## SAWS DOS RIOS SLUDGE BLEND FACILITIES EXPANSION PROJECT

Solicitation Number: CO-00080

### ADDENDUM 1

September 22, 2016

SHEET **G-05**  
5 OF 54

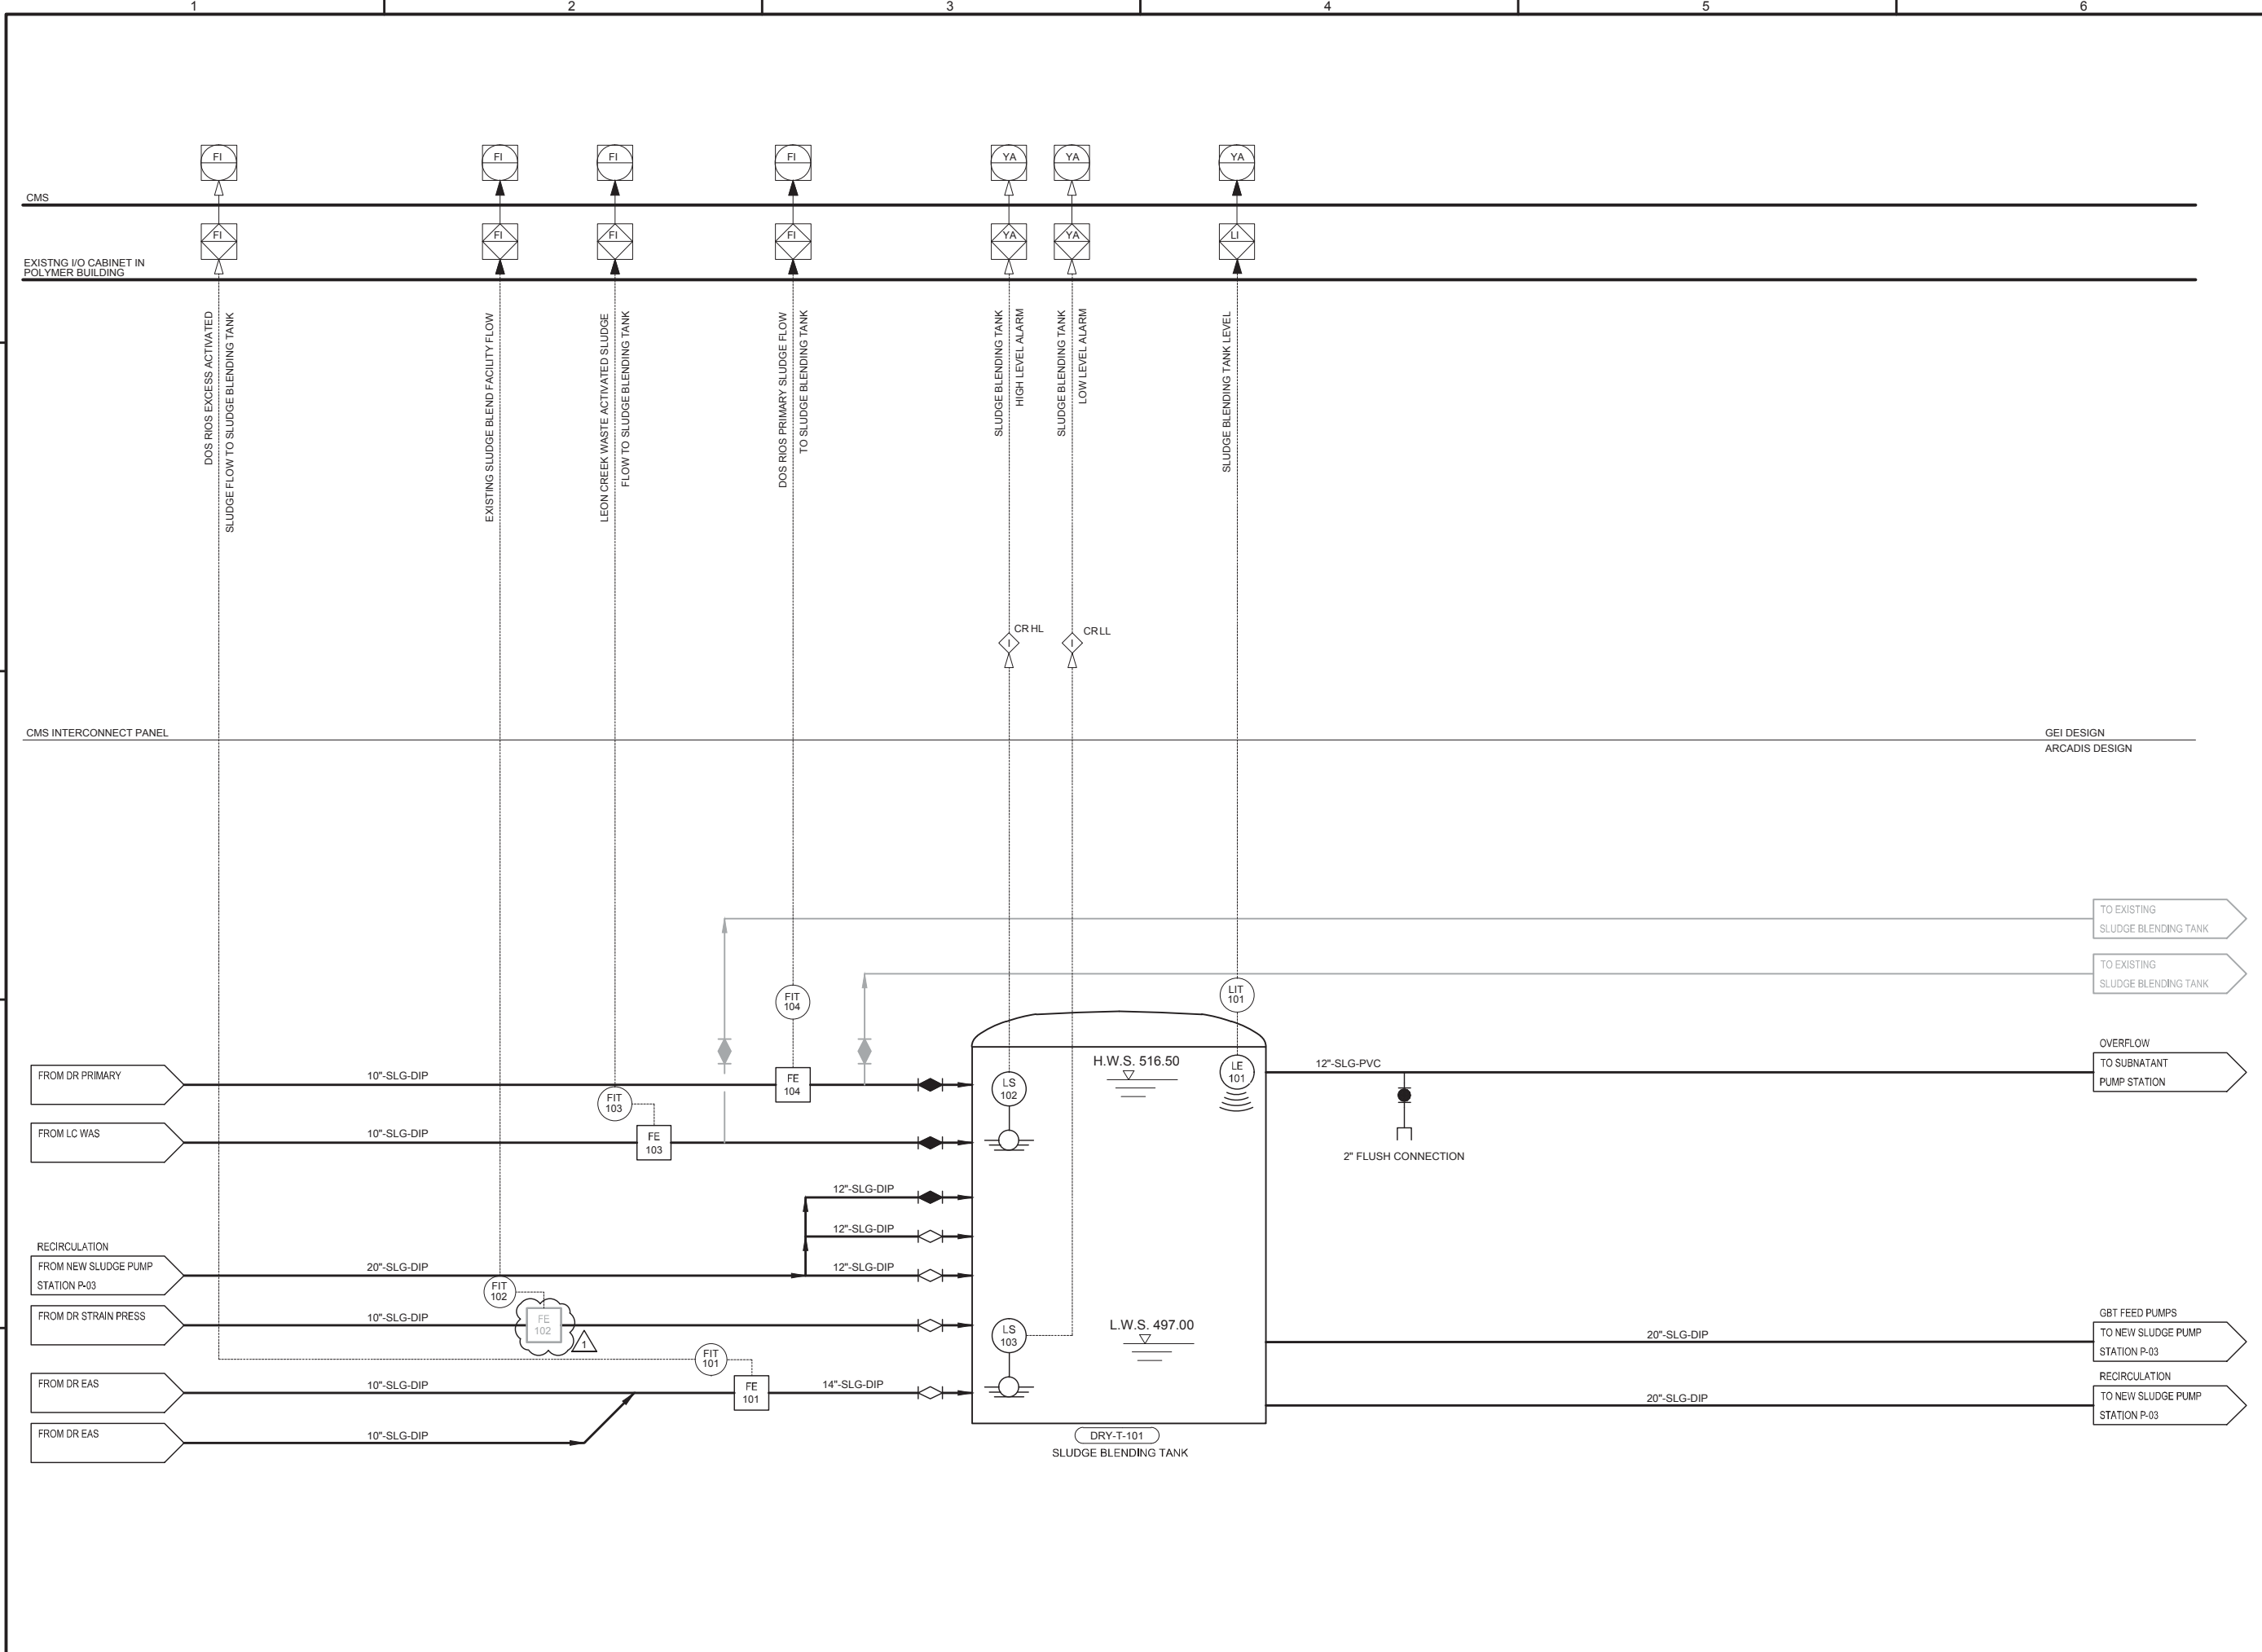
**10. What size is the magnetic flowmeter for tag #FIT 102. I think it is the sludge blend train? I found it in the specs but not on the plans.**

Response: Flow meter Tag # 102 is a 10" existing magnetic flow meter shown on Sheet G-05 in gray coming out of the strain press building. It is also shown on Sheet E-09 keynote 14. Refer to updated Sheets G-05 and P-02, which are included as part of this Addendum No. 1.

1. Sheet G-05 - Replace the sheet with the attached.
  - a. Instrument ID #'s added to flow meters for clarity.
2. Sheet P-02 – Replace this sheet with the attached.
  - a. Flow meter 102 line weight changed to gray to indicate existing.
3. Sheet P-03 – Replace this sheet with the attached.
4. Sheet M-06 and M-07 – Replace sheets with the attached.
  - a. Detail 2 – Added existing centerline elevation of inlet pipes to the GBT's to each sheet.
5. Sheet M-04 - Replace this sheet with the attached.
  - a. Note 7 added.
  - b. Blinded tee removed and replaced with straight pipe.
6. Sheet M-11 - Replace this sheet with the attached.
  - a. Piping configuration on Detail 4 updated.
7. Sheet E-04, E-06 through E-14 - Replace these sheet with the attached.

SHEET TITLE  
 MECHANICAL  
 GBT FEED PUMP STATION PLAN  
 SCALE: 3/8" = 1'-0"  
 SHEET M-04  
 27 OF 54

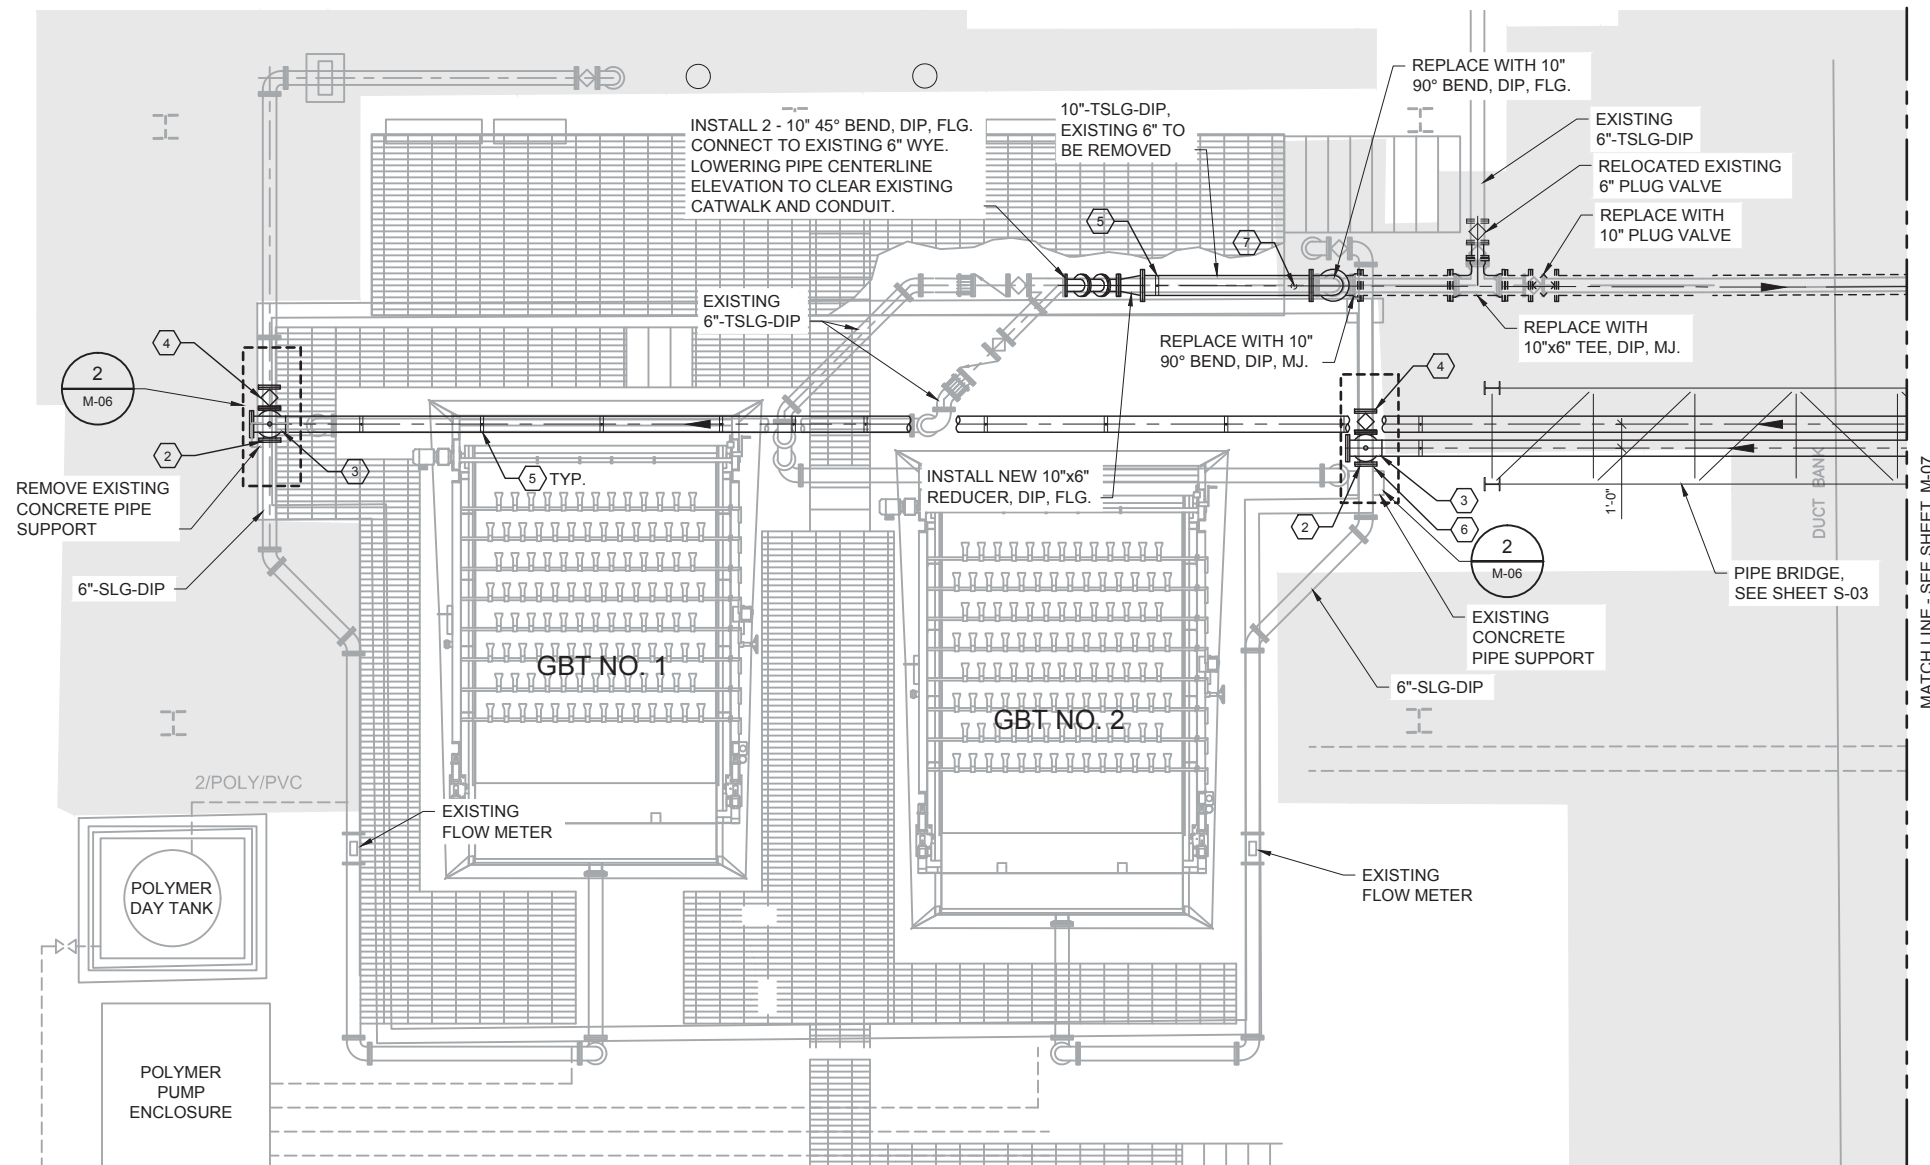
**13. On sheet M-04 the plans call out a 90° bend coming off the tee for a the 8" line leaving pump one but on sheet M-05 it does not call that out. Should this be an 8" blind flange?**

Response: Yes. An 8" blind flange should be provided. SAWS will install the piping shown in gray. This is why keynote 9 on Sheet M-04 points to the gray portion of pipe.

SCALE: AS SHOWN  
SHEET **M-06**  
29 OF 54

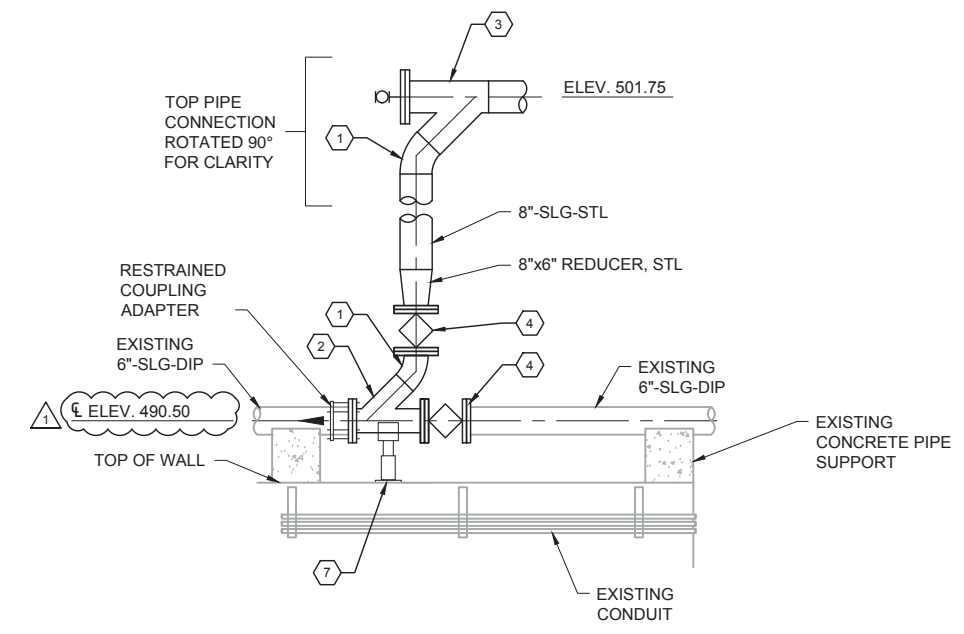
**14. What is the length of pipe from the reducer and wye on the sludge piping connection detail that is shown on sheet M-06 and M-07?**

Response: Centerline to centerline on sheet M-06 is approximately 11.25 feet. Centerline to centerline on sheet M-07 is approximately 13.3 feet. Contractor should field verify all distances in accordance with note 1 on both sheets.

SHEET E-06  
44 OF 54

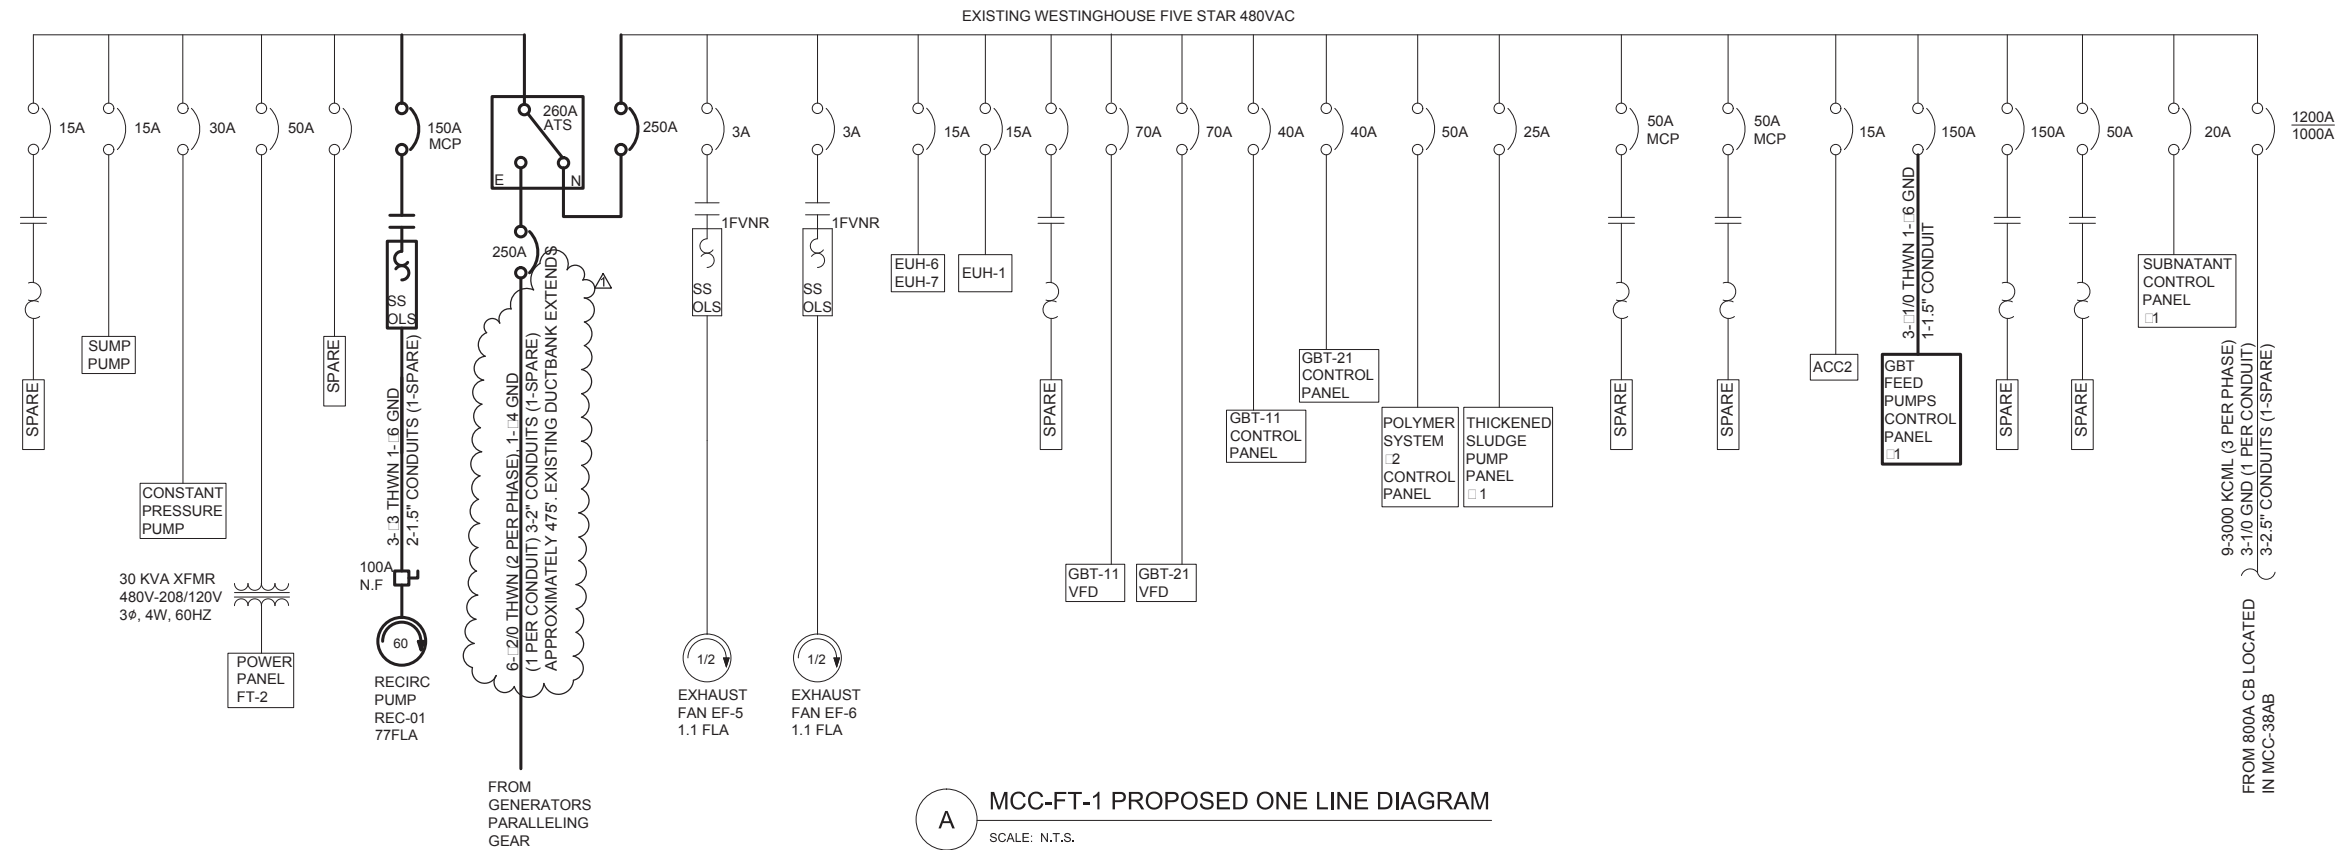
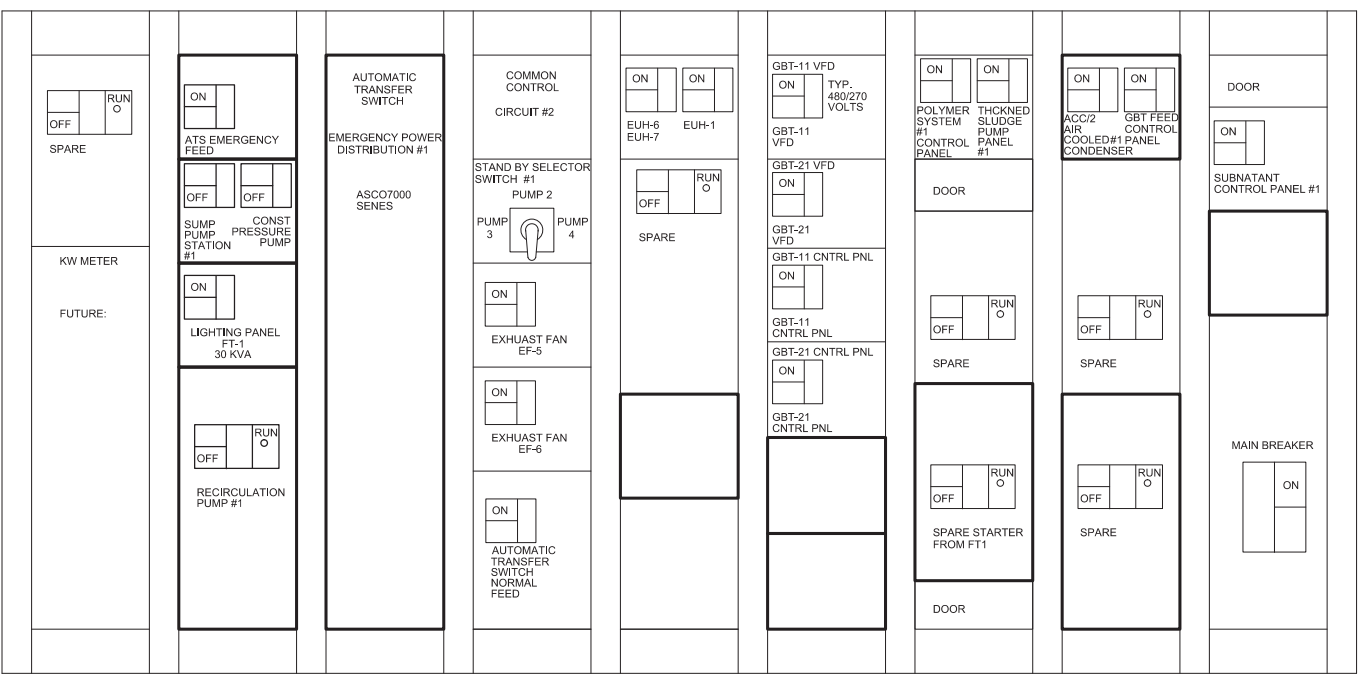
**15. Sheets E-06 and E-08 shows we are to replace the existing ASCO ATS in MCC-FT1 and MCC-FT2. It appears we are to replace the conductors from the ATS to the generator paralleling gear? How do we quantify the amount of wire that will be needed to replace the conductors? Is the existing raceway currently empty? Is the conduit new?**

Response: Yes, the conductors shall be replaced. Only conductors shall be replaced per revised sheets E-06 and E-08.
